Technical Note 01

Kronospan Response to LHA Consultation Response

June 2023

3046-01-TN01

Appendix C – Drawing No. 3046-01-D01A: Proposed Roundabout Layout and Visibility Splays

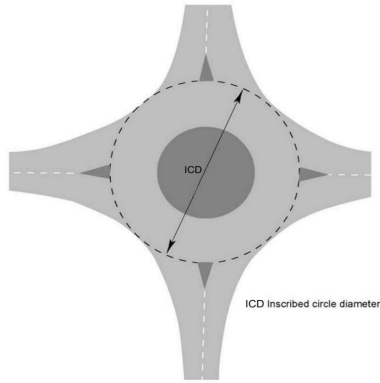
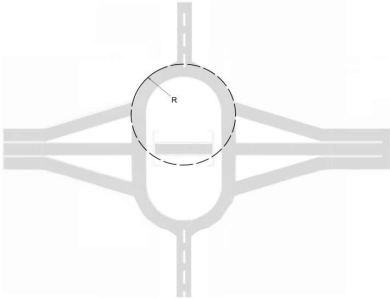
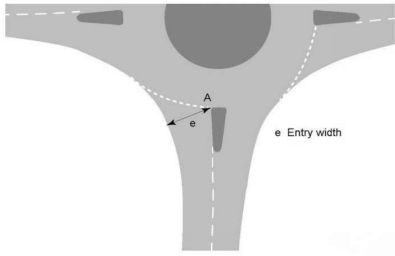
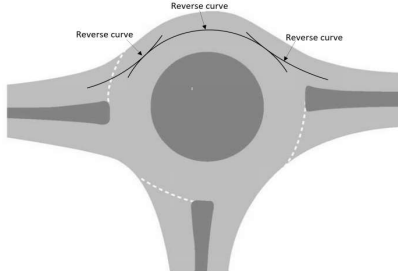
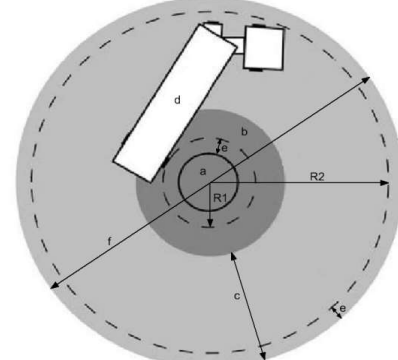
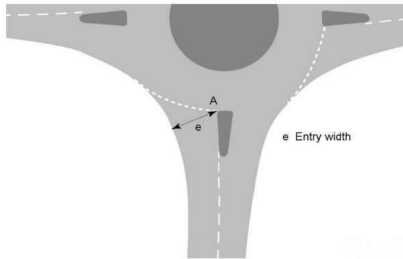
LHA Comment – “The applicant has provided visibility splays of 2.4m x 120m appropriate for a 40mph speed limit. Revised visibility splays should be provided in line with TAN18 for 50mph.”

LHA Comment - “The proposed roundabout layouts provided by the applicant (Ref. 3046-01-D01 & 3046-01-ATR01) indicate a compact roundabout design. A standard roundabout should be provided to accommodate the level of HGV movements to and from the site. This should comprise two circulatory lanes and a flared two-lane entry at the B5070 north arm. The right entry lane should be of sufficient length to accommodate a right turning HGV with the left lane for general traffic”

- 2.3.1 Contrary to the comments provided in the LHA response, it is considered that the visibility splays for the proposed roundabout included on **Drawing No' 3046-01-D01** contained within **Appendix C** are appropriate for the anticipated design speed of the road, following the reduction of the posted speed limit to 40mph.

- 2.4.1 The LHA has indicated that a normal roundabout would be required in order to accommodate the level of HGV movements associated with the Proposed Development. The proposed roundabout (including its classification as a compact roundabout) has been designed in accordance with the guidance provided in the Design Manual for Roads and Bridges (DMRB) CD116. To this end, a CD116 compliance checklist was submitted alongside the TA and is reproduced in **Appendix D**.

- 2.4.2 Review of the CD116 checklist indicates that a compact roundabout would be permissible in this location. It is evident from the checklist that the proposed roundabout is compliant with CD116, with minor relaxations in the interest of the efficient use of space, highway safety, and in order to fit the roundabout into the context of the site.

- 2.4.5 The reasoning provided by the LHA that the Proposed Development traffic could not be accommodated on the proposed compact roundabout is unfounded. As agreed by the LHA, detailed junction capacity assessments of the proposed compact roundabout were included in the TA. The results of the capacity assessment indicated that the proposed roundabout would be able to accommodate development traffic satisfactorily with significant residual capacity. Indeed, the operation of the roundabout could be expected to result in a maximum queue of less than 1 PCU during the most robust future scenario. It is not therefore clear on what basis the LHA have asserted that the proposed roundabout is unsuitable for development traffic.

- 2.4.6 If it is inferred from the response that the LHA is concerned that a multiple lane entry / exit arm would be required in order to accommodate the manoeuvres of HGVs to and from the site, again this is unfounded. The swept path analysis provided in the TA (**Drawing No: 3046-01-ATR01** contained within **Appendix E** at the end of this report) demonstrates that a single lane entry / exit would be sufficient to accommodate the manoeuvres of a 16.5m long articulated HGV. This is consistent with paragraph 3.14.3 of DMRB CD116 which states that “*Vehicle swept paths should be assessed using the largest design vehicle that is anticipated to use each entry lane*”. The LHA’s response infers that compact roundabouts are not able to accommodate the swept paths / manoeuvres of large HGVs. Given sufficient entry / exit kerb radius, circulatory carriageway width and various other factors as set out in CD116 for compact roundabouts, this is demonstrably not the case.

- 2.4.7 Ultimately, it is considered that a compact roundabout is compliant with design standards, appropriate for the location and sufficient to accommodate development traffic.
